**FINAL IMPLEMENTATION DOCUMENT
OTHER CONTAMINATION SOURCES
INTERIM RESPONSE ACTION
SOUTH TANK FARM PLUME**

APPENDIX C - Responses to Comments on the Draft
Implementation Document, Other
Contamination Sources, Interim
Response Action South Tank Farm
Plume.

**RESPONSES TO COMMENTS ON THE
DRAFT IMPLEMENTATION DOCUMENT
OTHER CONTAMINATION SOURCES
INTERIM RESPONSE ACTION
SOUTH TANK FARM PLUME**

Annual Monitoring
Network

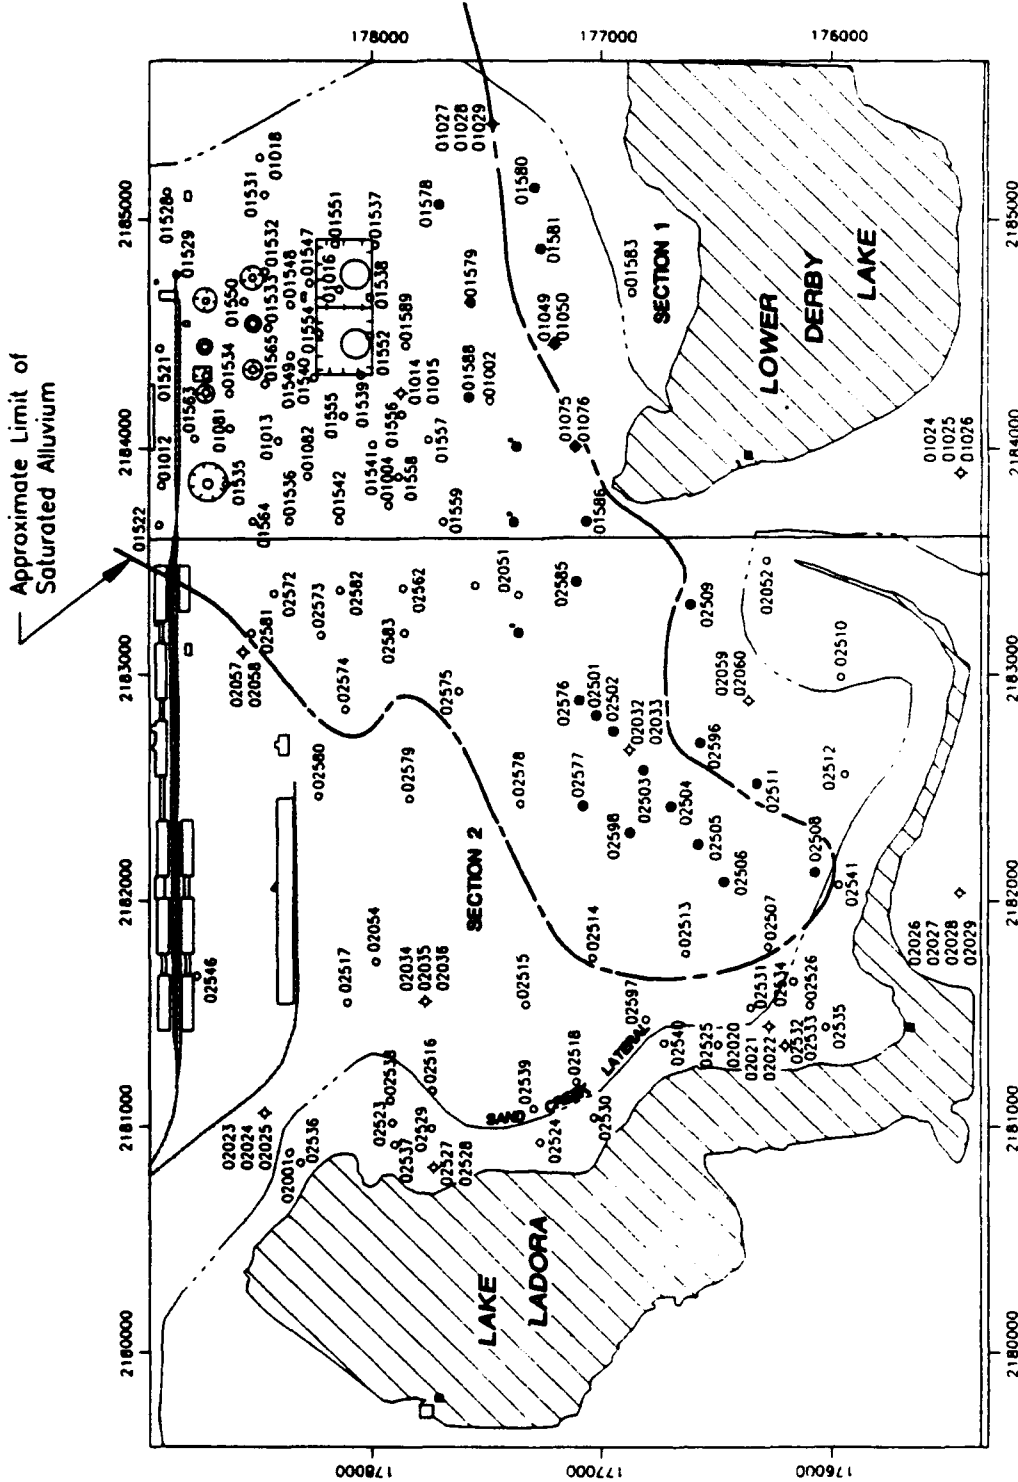
6. Figure 4. The annual monitoring network as presented by Shell in this figure excludes two wells originally included

in the sampling program in the Final Decision Document Other Contamination Sources Interim Response Action South Tank Farm Plume, May 1991 ([Final Decision Document], Figure 4-2), Wells 02577 and 02598. Well 02577 had spring 1988 and spring 1990 benzene detections of 94.2 ug/l and 37.7 ug/l, respectively, and Well 02598 had a spring 1990 benzene detection of 89.6 ug/l (these two wells both had fall 1989 and fall 1990 concentrations below detection limits, again indicating cyclicity in the data). Additionally, both wells had detections of 11DCLE, 12DCE, CHCL3, and TRCLE. Please include these wells in the annual monitoring network as originally presented in the Final Decision Document.

Response: Figure 4 has been corrected to show that these wells are included in the monitoring network.

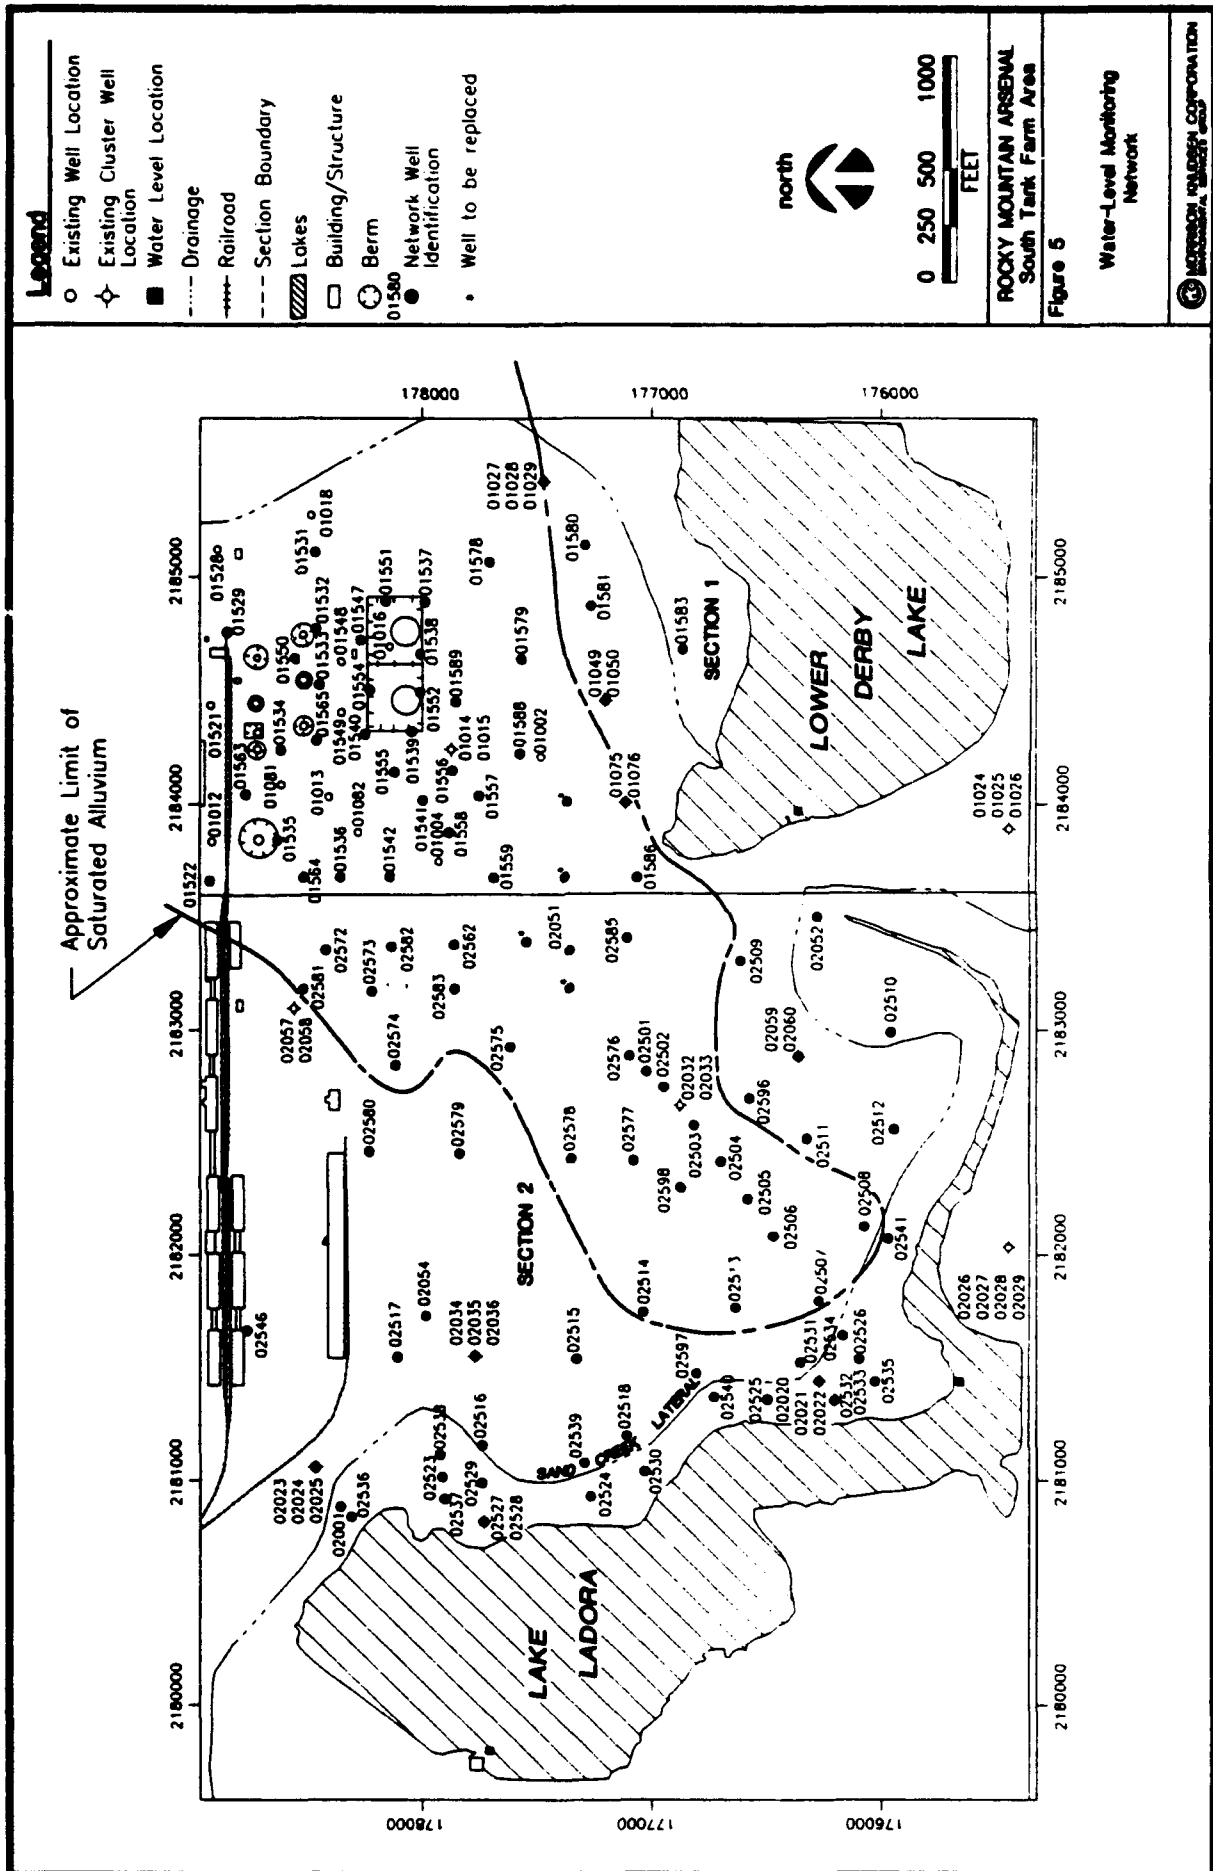
3. Figure 3. The figure indicates that Well 01538 was sampled during the fall 1990 sampling program, and Well 01537 was not. Based upon the Appendix to the Verification Monitoring

Program Document, these two wells should be reversed; please modify the figure accordingly.

Response: Figure 3 has been corrected.

**LOCATION MAP FOR NEW
WELL PONTS AND
PIEZOMETERS**

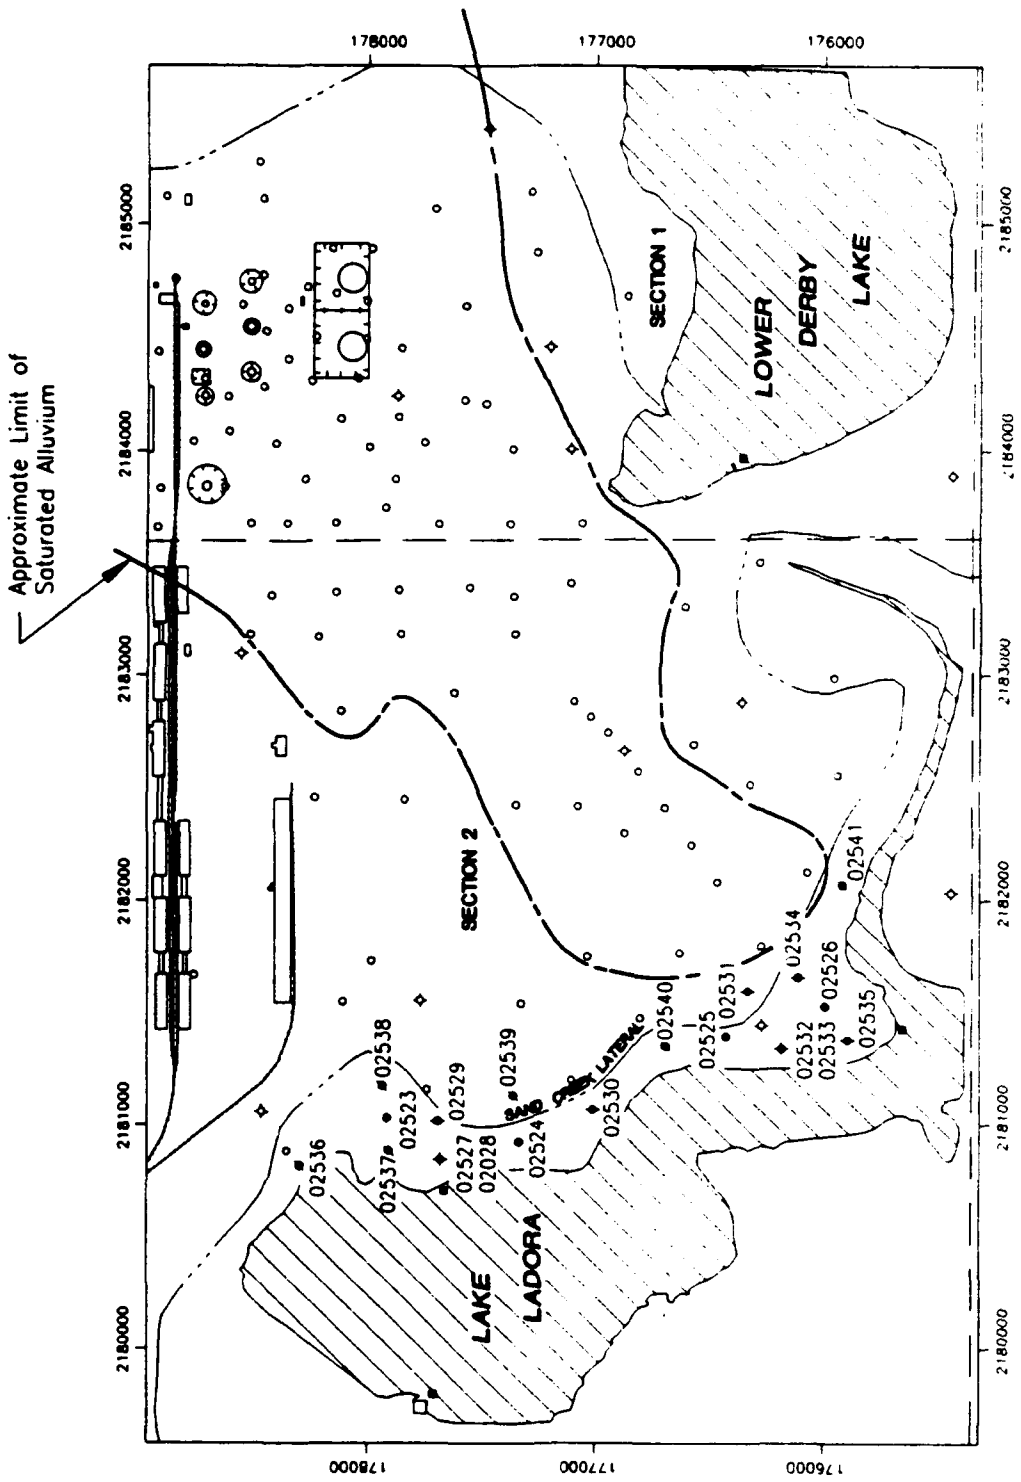
1. Page following page 3-5, Figure 6. One of the piezometer locations is reported as Well 01231. This appears to be a typographical error. This location corresponds to Well 02531 shown on Figure 5. Please confirm this well's proper identification number and correct Figure 6 accordingly.

Response: The well number has been corrected on the figure.

Water Table
Contour Map
June 1991

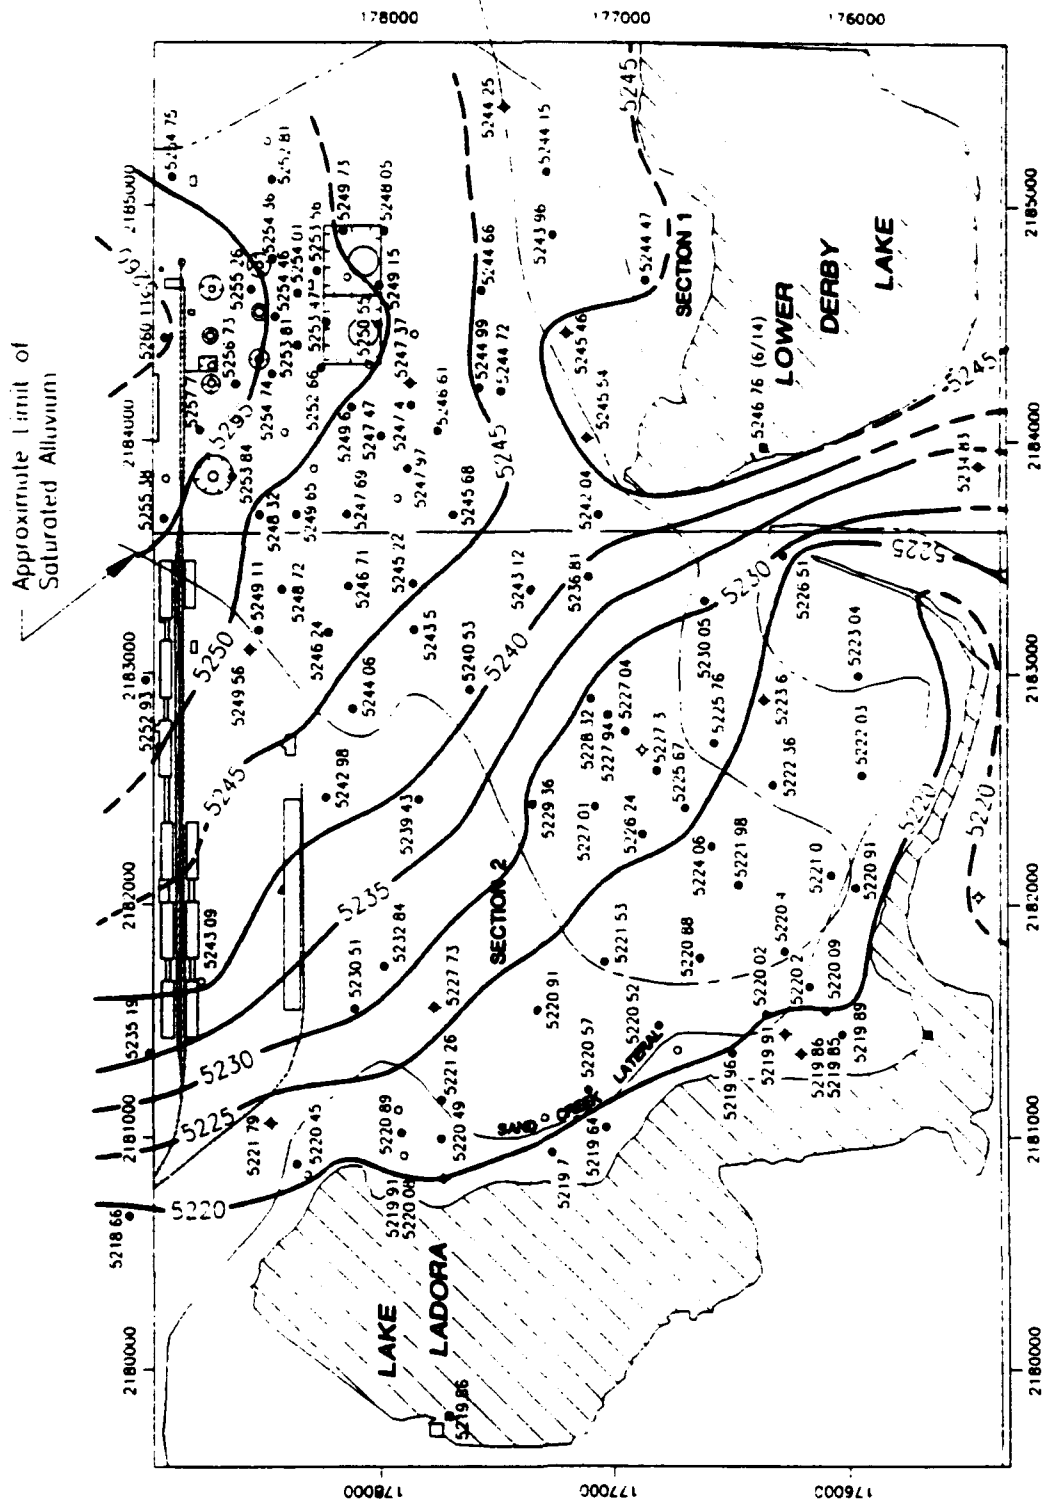
3. Appendix A, page A-2. Please clearly specify: exactly how many staff gages were installed; in which lake(s) they were installed; the date(s) measured; and the elevation datums for all staff gages, whether previously existing or new. Please show the location of the existing staff gages (and newly installed gages) on Figures 8 and A-1.

4. Appendix A, page A-2, third paragraph, second to the last sentence. Well point 02539 was reported as unplugged after using a variety of well development techniques. However, the water-table elevation measurement for this well was not given. Please provide this information on Figure A-1.

7. **Page A-2.** Shell states that two staff gages were installed along the eastern edge of Lake Ladora, however, the gage locations are not presented on Figure A-1. Please include these locations on the figure.

Response: Two staff gages were installed on the eastern edge of Lake Ladora. One is aligned with Wells 02527 and 02528, and the other was originally aligned with Well 02535. As stated on page A-2 of this document, this staff gage was relocated to the southern end of the lake on August 7, 1991. The text and figures have been modified according to the EPA's request.

Response: A water level was not provided for Well 02539 because the well was unplugged after the water level

Response: The figures now include the location of the two new staff gages.
